Proposed amendment to Appendix 9 to the GCU

Title:	New drawing for the correct assembly of tare springs and load springs in the suspension systems of Y 25 bogies or derived systems
Proposed amendment made by RUs/keepers/others:	MERCITALIA RAIL/AFWP Appendix 9 subgroup
Proposed amendment to:	<input checked="" type="checkbox"/> Appendix 9 <input type="checkbox"/> Appendix 11
Proposer:	Francesco Garrisi, Mercitalia Rail
Location, date:	Florence, 07/01/2021
Concise description:	New drawing, code 2.5

Appendix C - Coil springs - Standardisation

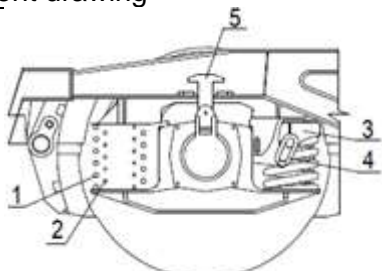
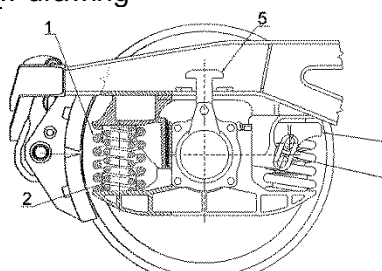
No Yes (state which): UIC leaflet 517, Appendix C

Current drawing	New drawing

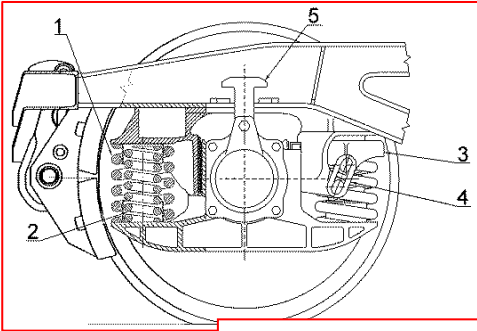
There is a need to add a drawing in Appendix 9, Annex 1, code 2.5 that more clearly shows that the two springs should be assembled with the coils wound in the opposite direction to each other.

The irregularity class for code 2.5.2.1 should be changed to 4.

Component	Code no.	Irregularities/Criteria/Notes	Action to be taken	Irregularity class
Suspension system of Y 25 bogies or derived systems	2.5	 <p>1 Tare spring* 2 Load spring* 3 Spring cap 4 Damper ring 5 Lifting T</p> <p>*Coils wound in opposite directions</p>		
	2.5.1	Main/tare spring cracked or broken	Detach wagon	5
	2.5.2	Auxiliary/load spring displaced or broken		
	2.5.2.1	- on empty wagon	K	4 3
	2.5.2.2	- on loaded wagon • axle box no longer horizontal	Detach wagon	5

Indicate the winding direction of the springs
